CORRIGENDUM - 03 TO NIT NO-73065

Subject: Corrigendum-03 to Tender enquiry for Supply & Services of 400 kV GIS FOR OPTCL ERSAMA, PARADEEP PROJECT.

Project : OPTCL ERSAMA, PARADEEP Project Equipment / Item : SUPPLY & SERVICES OF 400kV GIS. Enquiry No/Date : Enquiry No 61G2300342 Dtd 05-04-2023

BHEL NIT NO : 73065

SINGLE LINE DIAGRAM OF 400/220kV

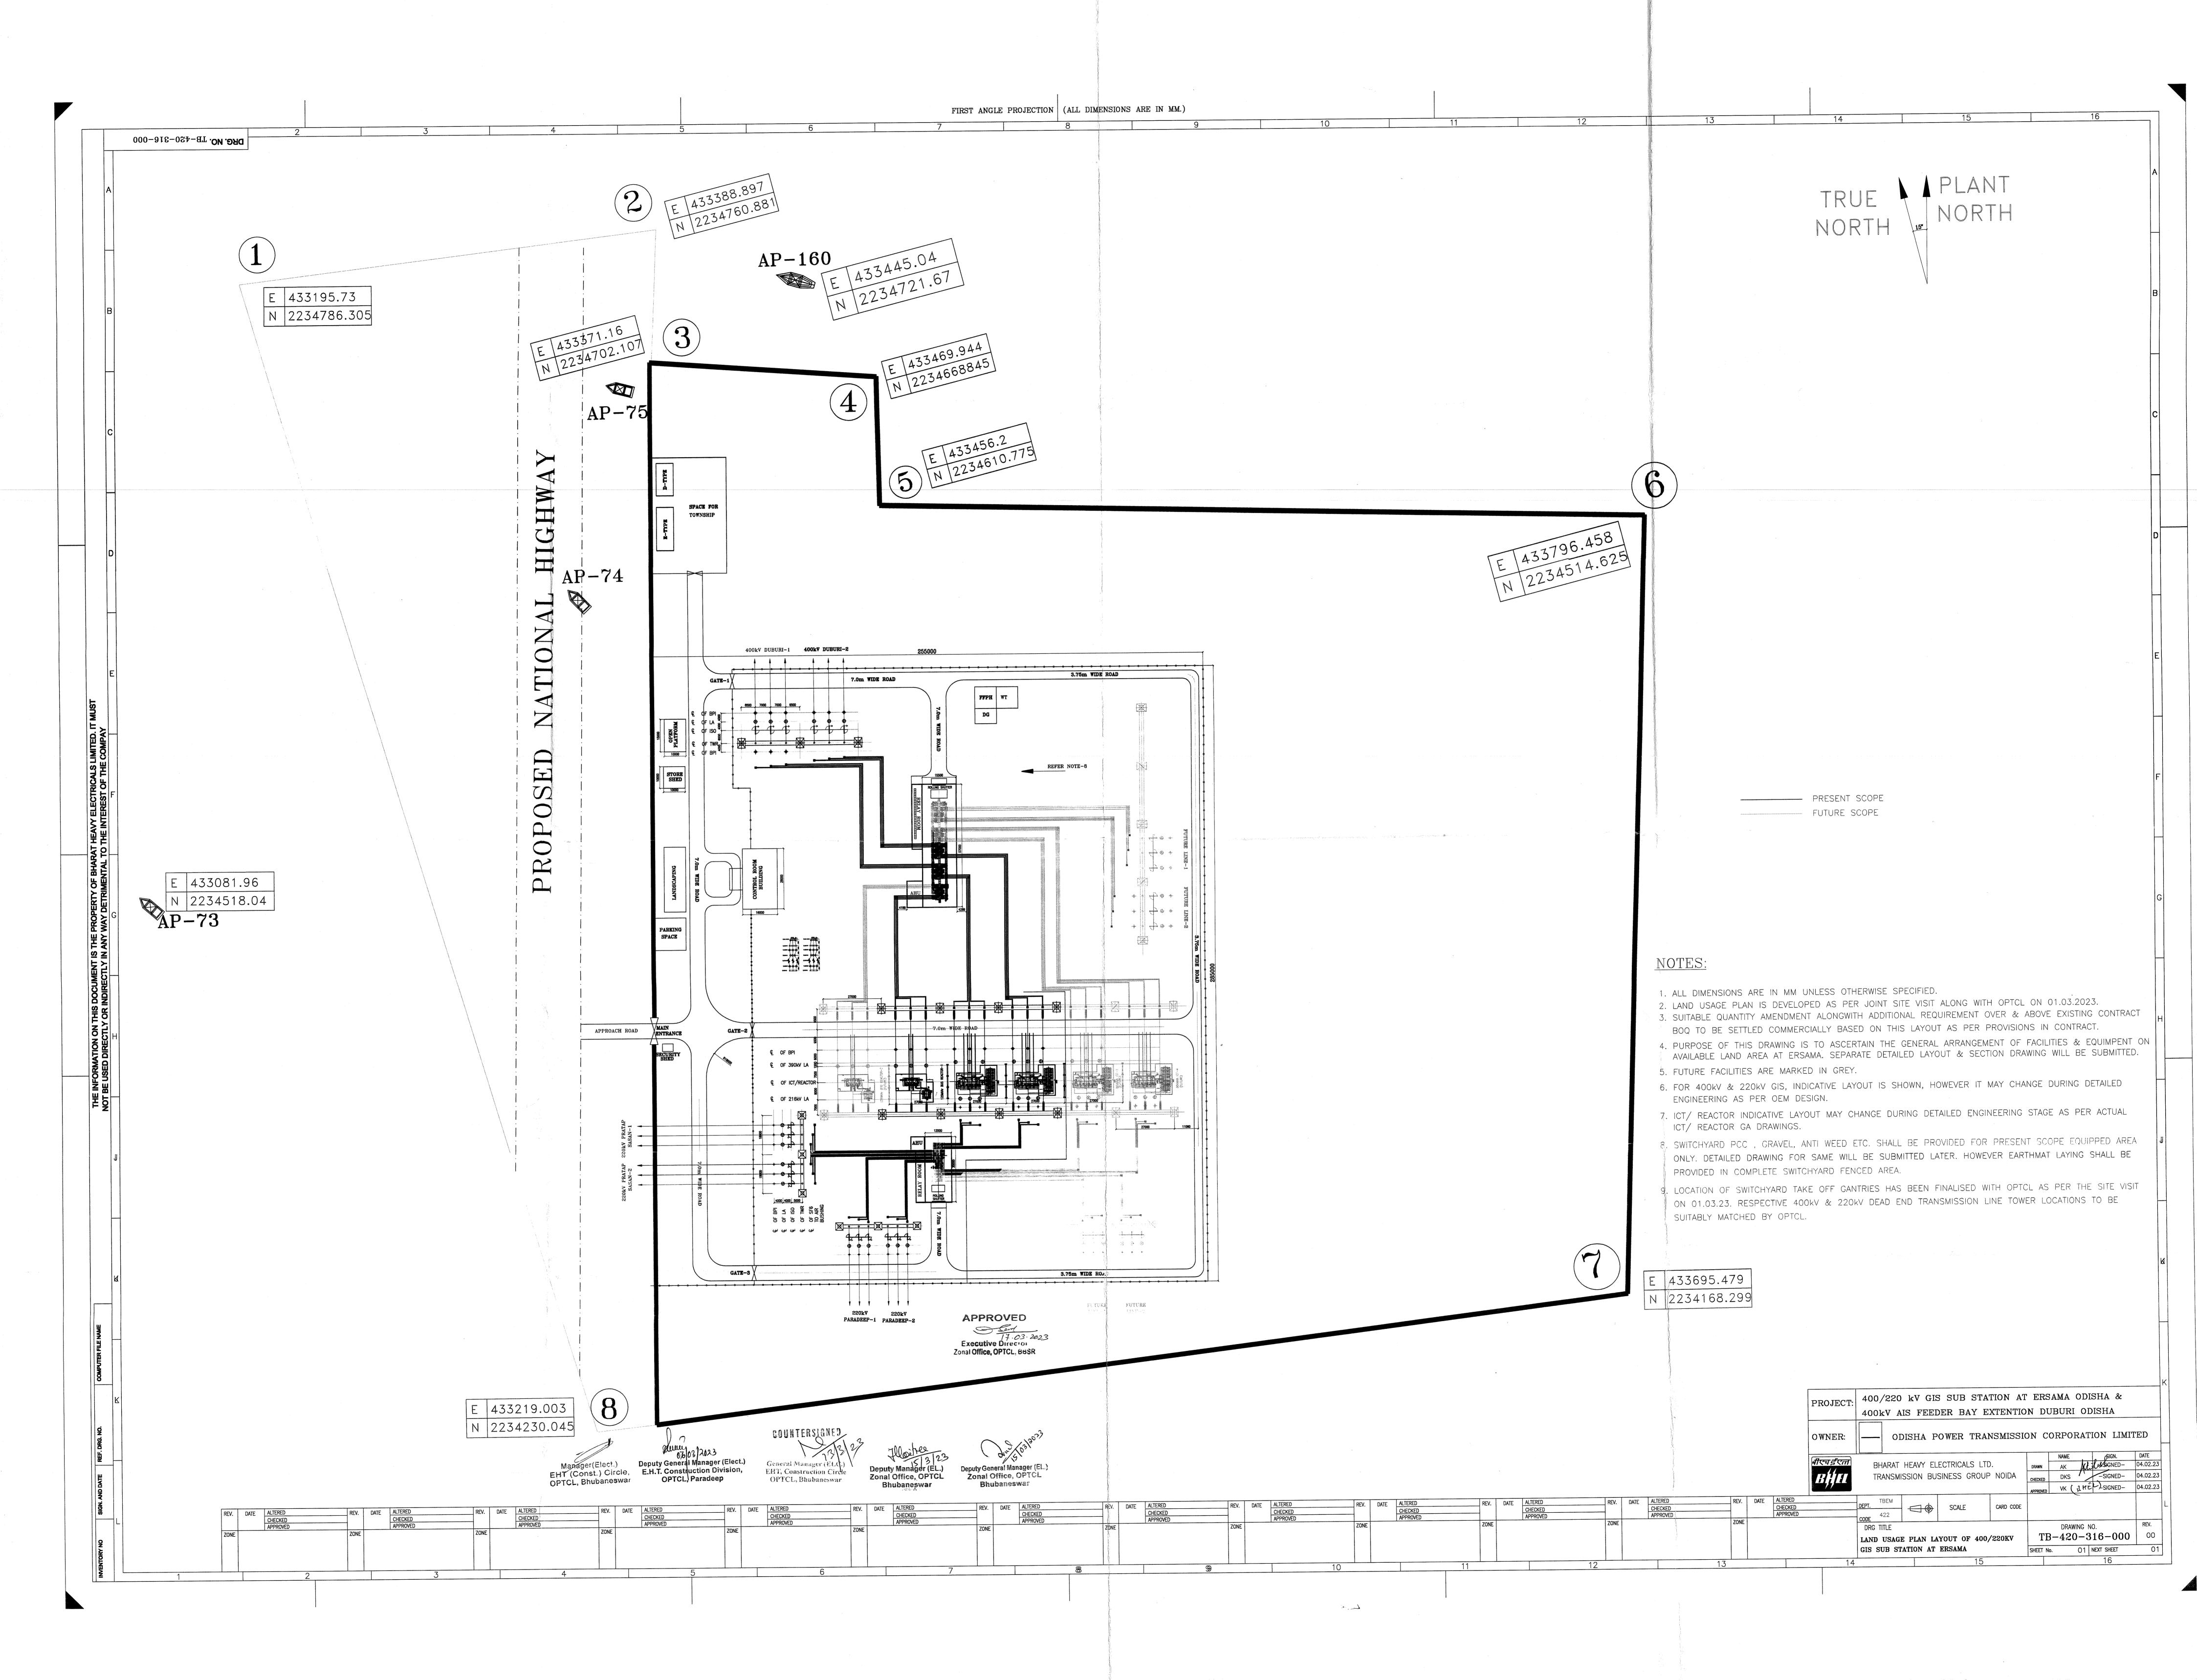
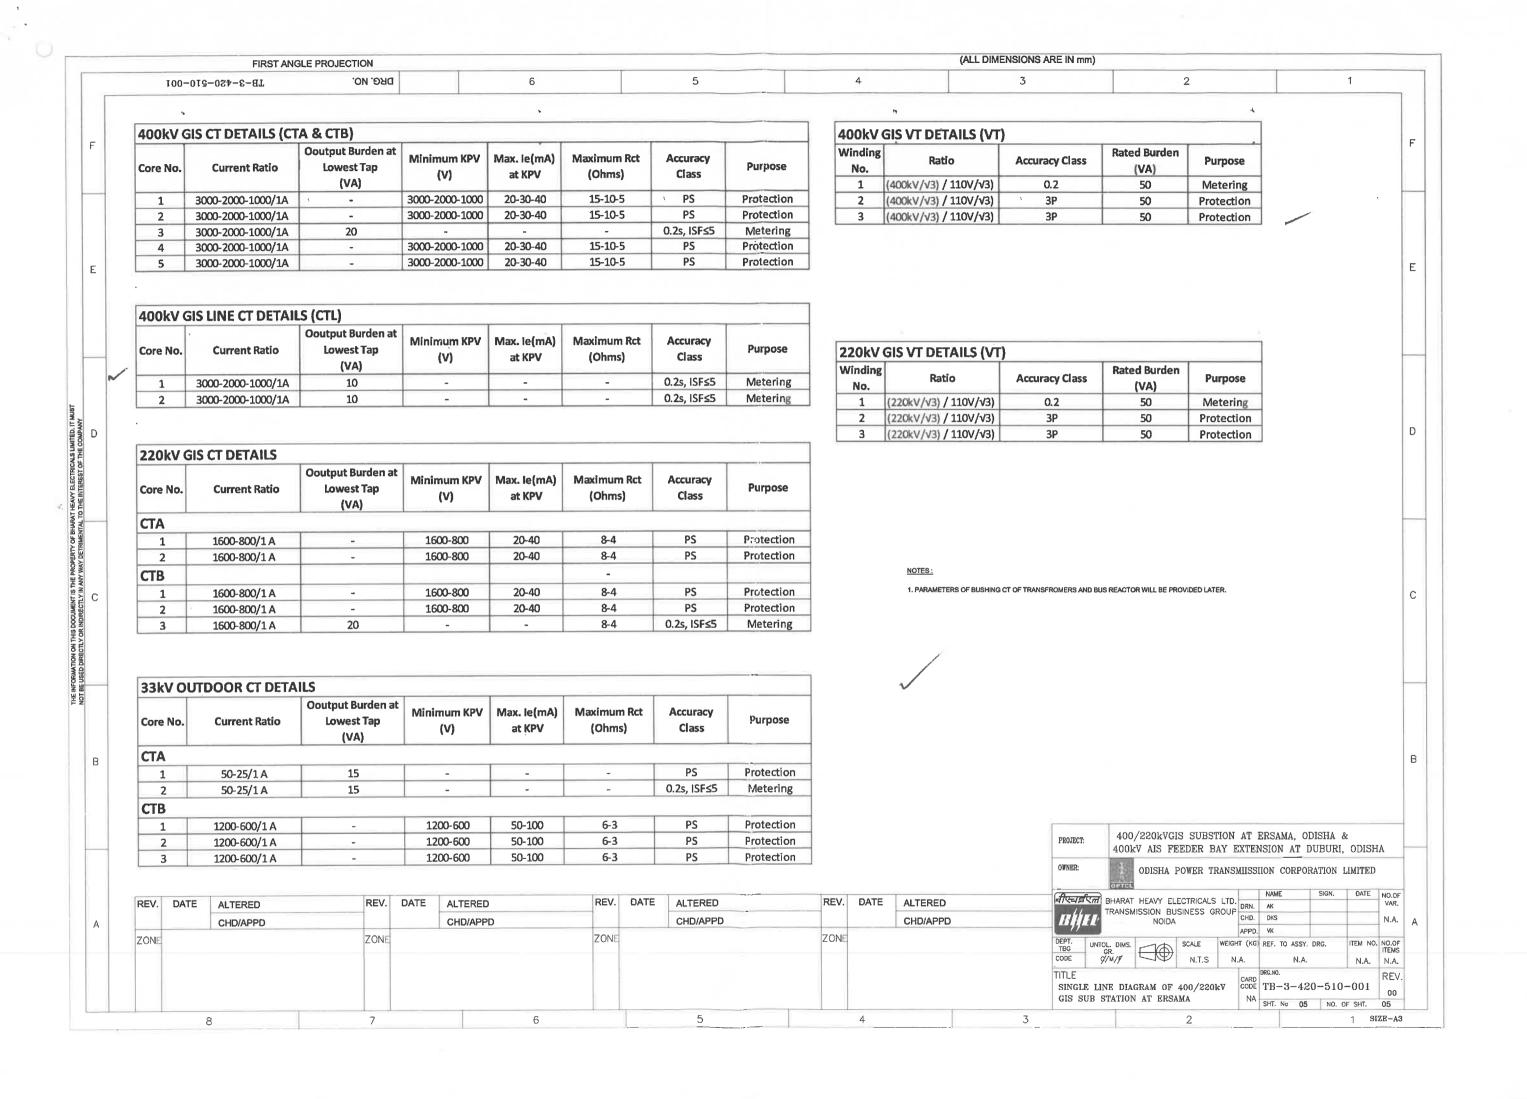
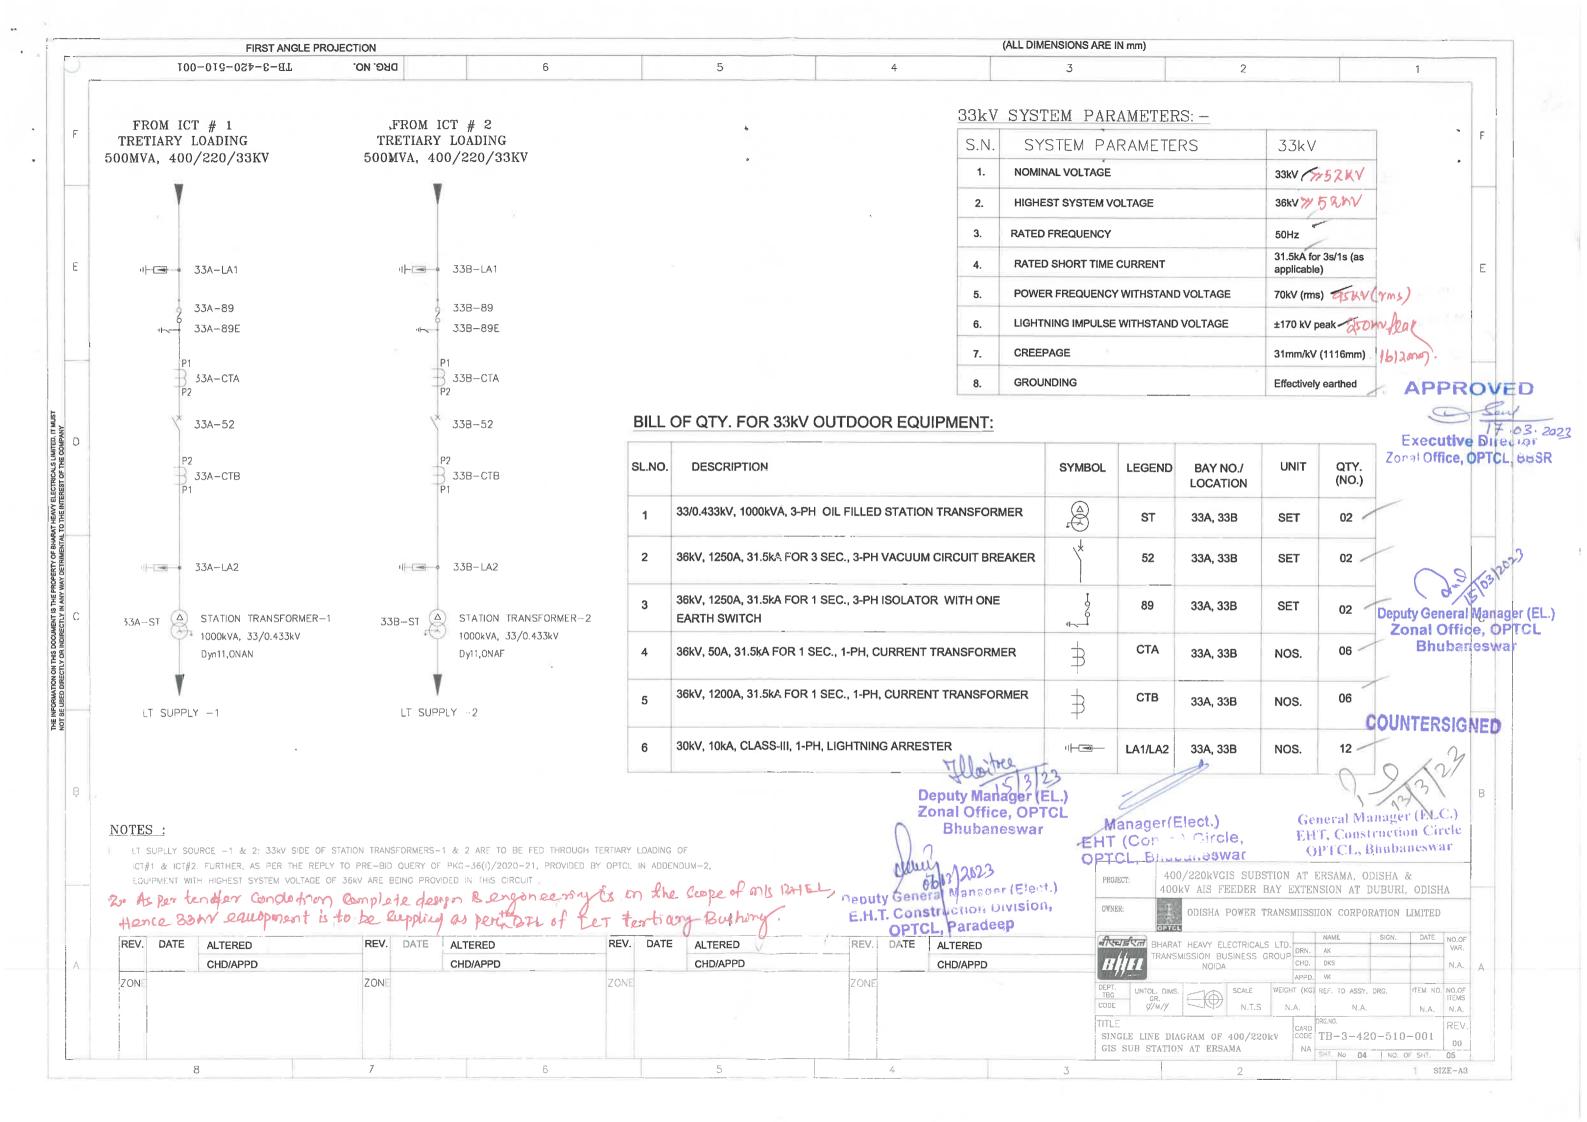
SI. No.	Clause no./ Doc	Document Description of Original Technical Specification	Technical Corrigendum-00	
31. 140.	Reference	Document Description of Original Technical Specification	Remarks, if any	
1	Annexure-BOQ: C.10	SF6 to Air bushing as applicable for 400KV GIS	SF6 to Air bushing (single phase) as applicable for 400KV GIS	
2	Annexure-BOQ: G.2	400kV, 3150A Disconnector (1 pole) without operating mechanism	400kV, 3150A Disconnector (3 pole) without operating mechanism	
3	Annexure-BOQ: G.5	Surge Arrestor including Surge Counter	Surge Arrestor (single phase) including Surge Counter	
4	Section-1: Clause no. 14 TB-3-420-316-001:	Single Line Diagram for 400/220kV GIS at Ersama	OPTCL approved Single Line Diagram for 400/220kV GIS at Ersama is enclosed.	
5	Section-1: Clause no. 14 TB-420-316-002:	Layout Plan & Section Drawing for 400/220kV GIS at Ersama	OPTCL approved Layout/ Land Usage Plan Drawing for 400/220kV GIS at Ersama is enclosed (Drg. No. TB-420-316-000).

6		SCHEME - TIE GIS RAV - 2 Sets	Quantity of SUPPLY- GIS: 400KV, 3150A, ONE & HALF CIRCUIT BREAKER SCHEME - TIE GIS BAY - 3 Sets as mentioned in Annexure-BOQ. Evaluation of offers shall be done considering quantity of Tie Bays as 3 Sets.
